Interactive comment on “Hydrological drought forecasting and skill assessment for the Limpopo river basin, Southern Africa” by P. Trambauer et al.

Anonymous Referee #2

Received and published: 21 November 2014

Fig. 1. Fig. 1 bias correction process (see text for explanation)

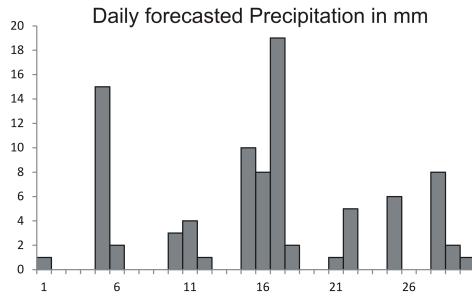
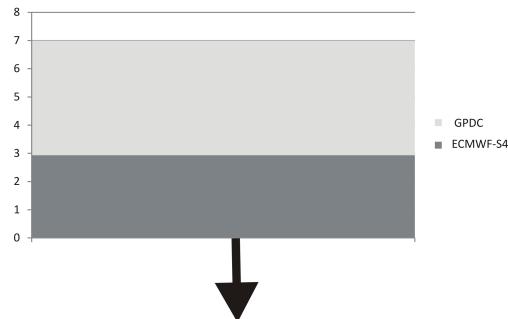
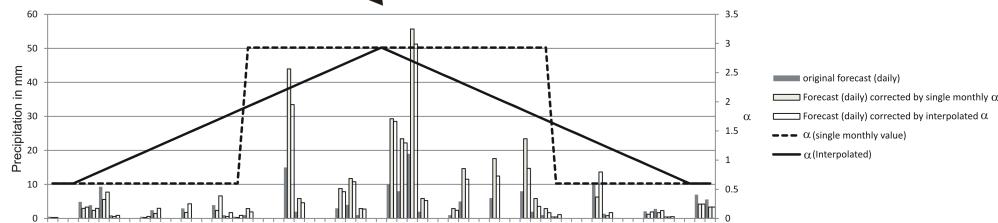
P 9971 According to a described precipitation bias correction the monthly mean correction factor is "linearly interpolated from monthly values to daily assuming it corresponds

to day 15 of the particular month". This might suggest that interpolation has been done the way illustrated in fig. 1. Daily time series (a) is bias corrected on monthly basis (b). Let's suppose the correction factor (alpha) is 2.39 for a given month and 0,6 for a preceding and following months. If this number is applied to correct daily rainfall uniformly during the given month the corrected monthly precipitation total would equal to 255 mm (8,5 mm per day) while if interpolated according to description of authors the monthly corrected total would be 214 mm (7,1 mm per day) only (c). I believe that was not the case, only a method description should be more precise.
